City of Tarpon Springs, Florida

REGULAR SESSION AGENDA AGENDA MONDAY, APRIL 1, 2024 6:30 PM - CITY HALL AUDITORIUM

1. APPLICATION 24.09: 127 N Grosse Avenue; Construct a single family detached structure;
(Continued from March 4, 2024, @6:30 P.M., Regular Meeting of the Heritage Preservation Board)
2. APPLICATION 24.17: 440 Cypress Street; Exterior renovations and addition.

HABITAT FOR HUMANITY APPLICATION #24-09

127 N GROSSE AVENUE – PROPOSED PROJECT

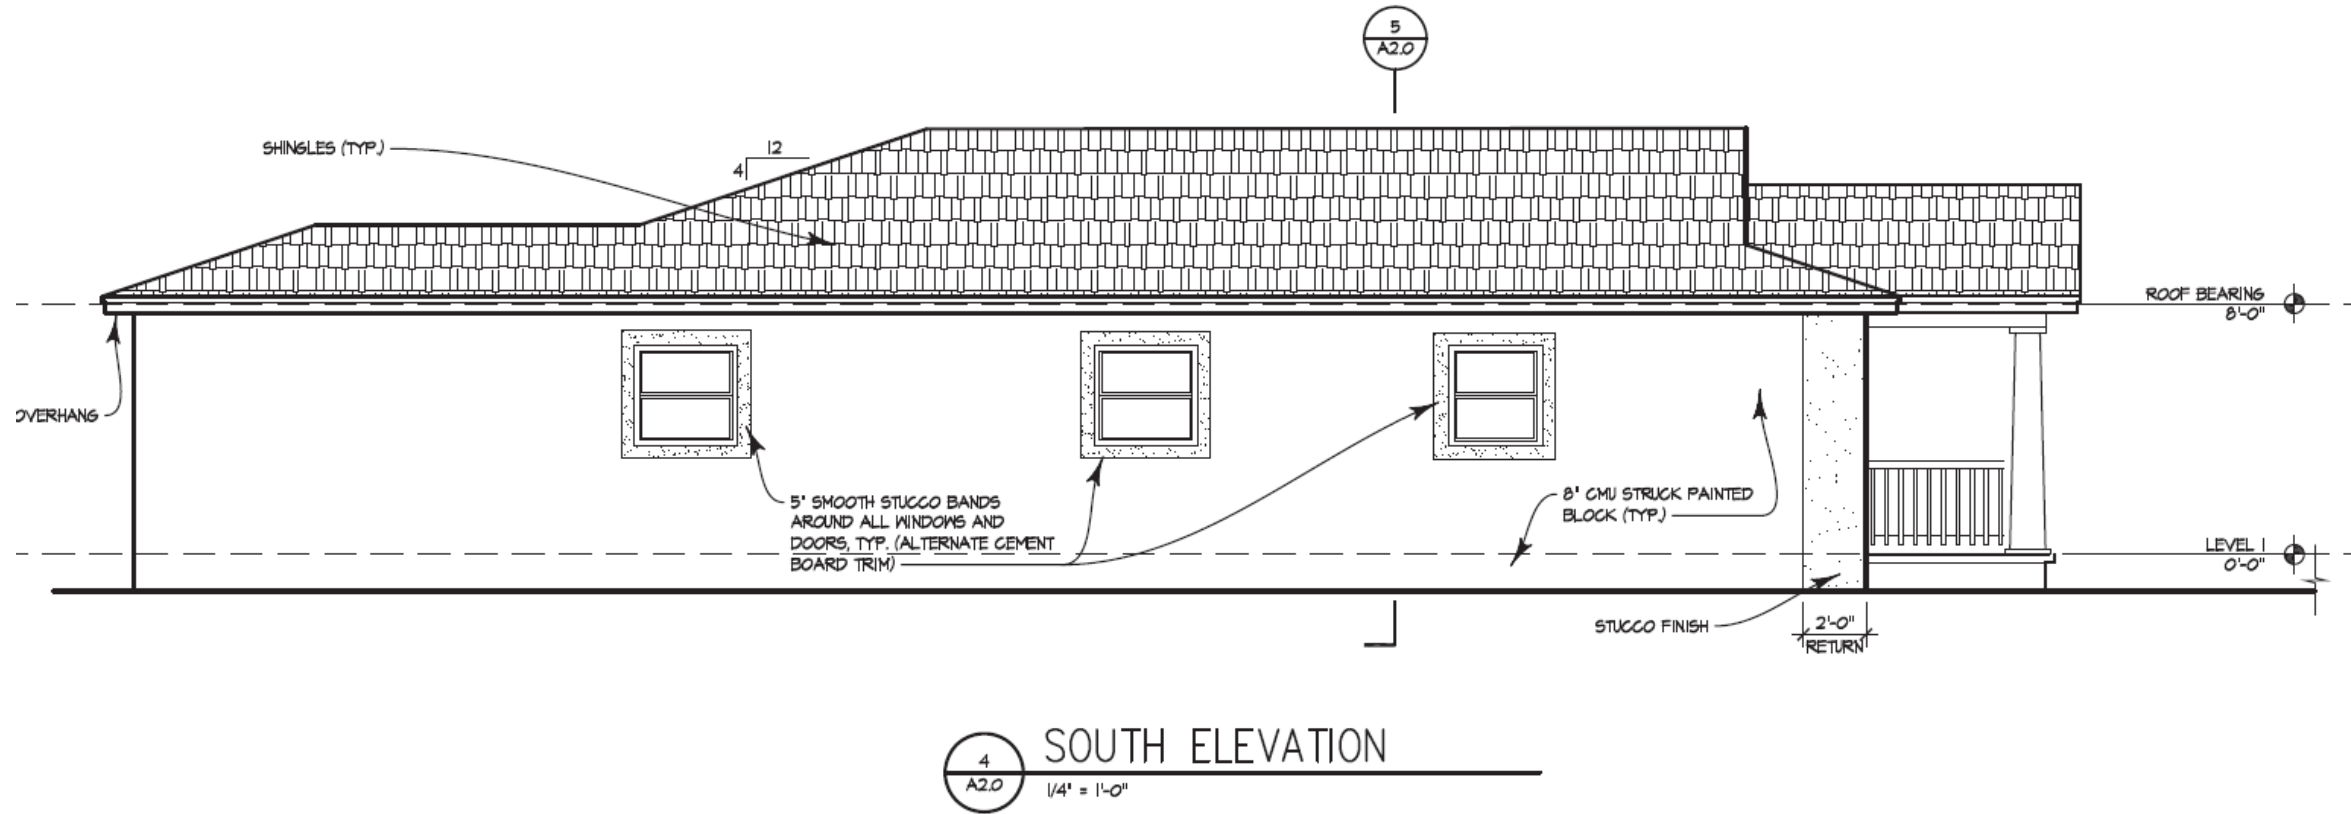
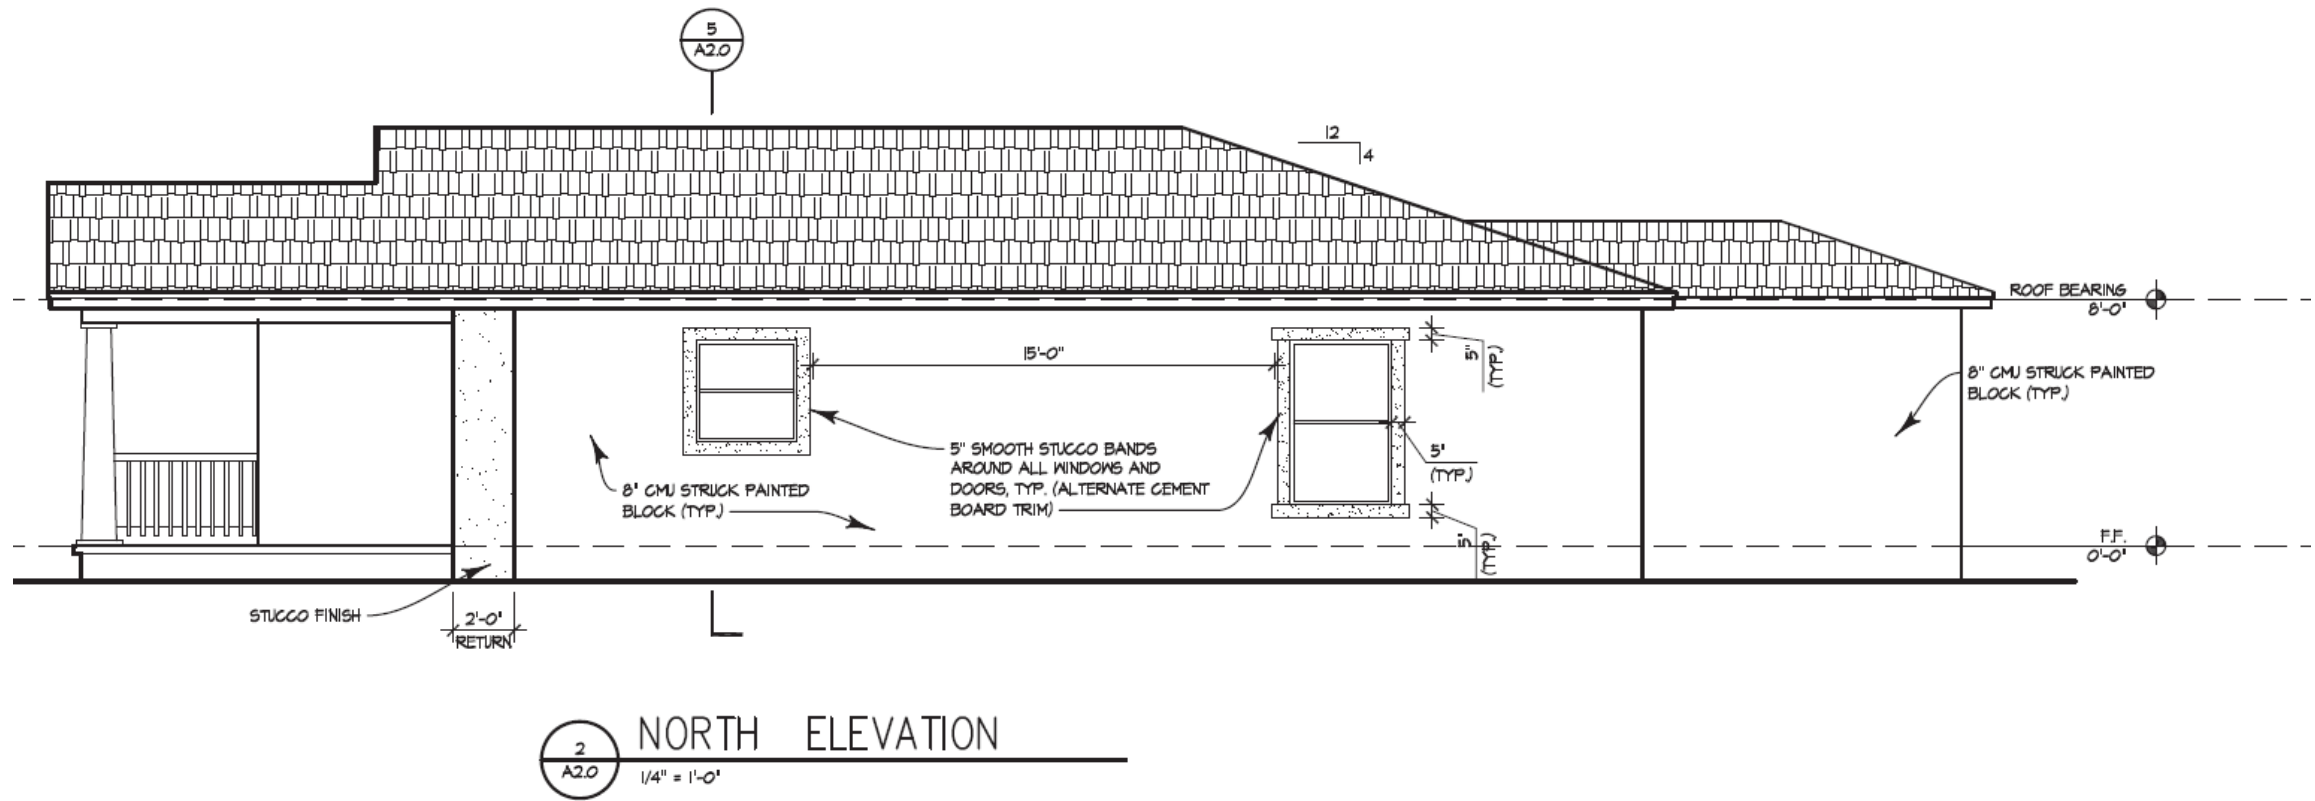
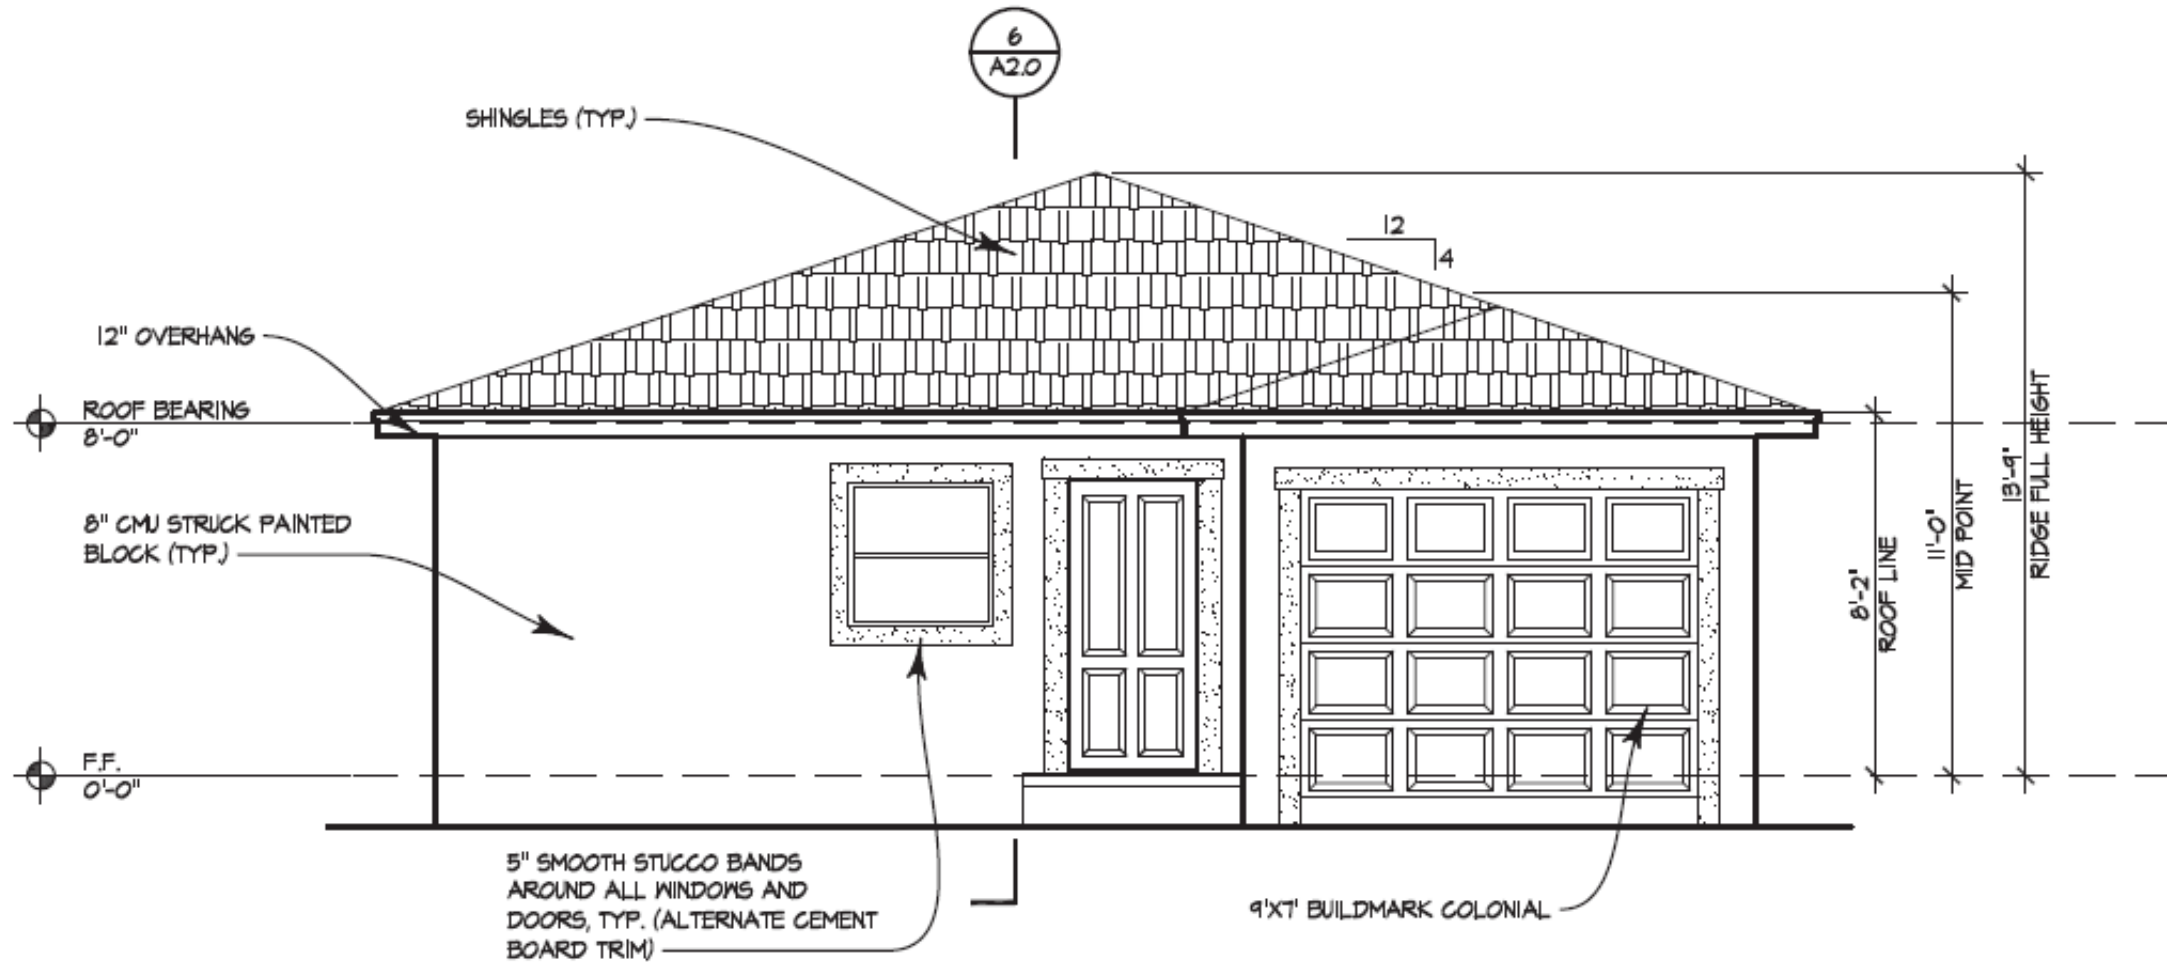
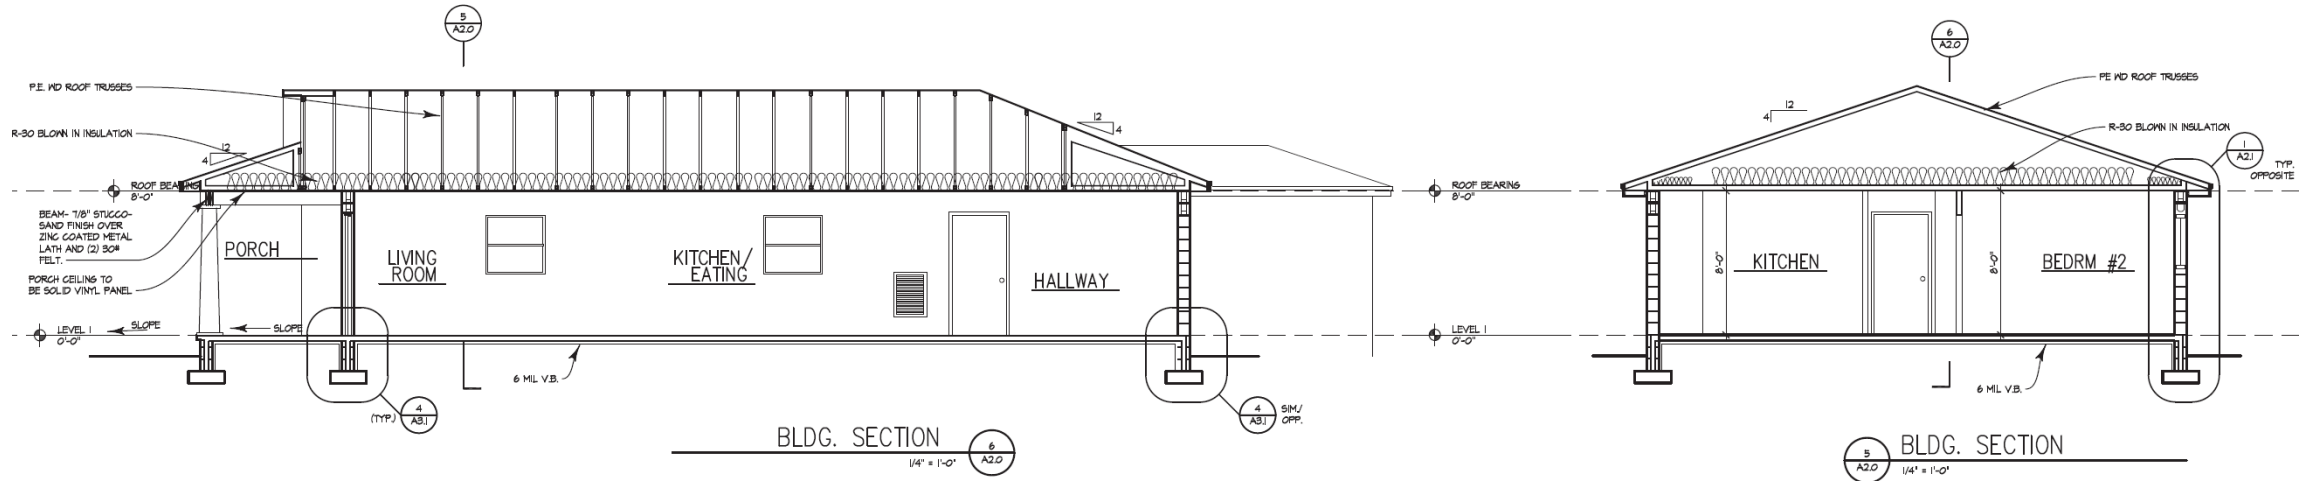
ANALYSIS: The width and height of entry doors and windows on the proposed new structure are comparable to historic structures in the vicinity. Plans provided indicate two 29-1/2" x 64" single hung windows on the façade, and adequate fenestration on the north and south elevations.

ANALYSIS: The proposed new structure will alter the historic streetscape and change the relationship between open space and the street through the construction of a single-story single-family residential structure on a currently vacant property. The proposed setbacks for the property conform to district standards and are similar to other properties in the immediate vicinity. The proposed front-gabled roofline is similar to structures in the immediate vicinity and throughout the district. The proposed

ANALYSIS: The size and mass of the proposed structure is compatible with contributing structures in the district and neighboring structures in the vicinity. The subject property is in an eclectic portion of the historic district where lot sizes and shapes, as well as architectural styles and age, vary. The rectangular plan, front-gabled roof, and simple design of the proposed project are generally complementary to the character of the district and contributing structures in the immediate vicinity.
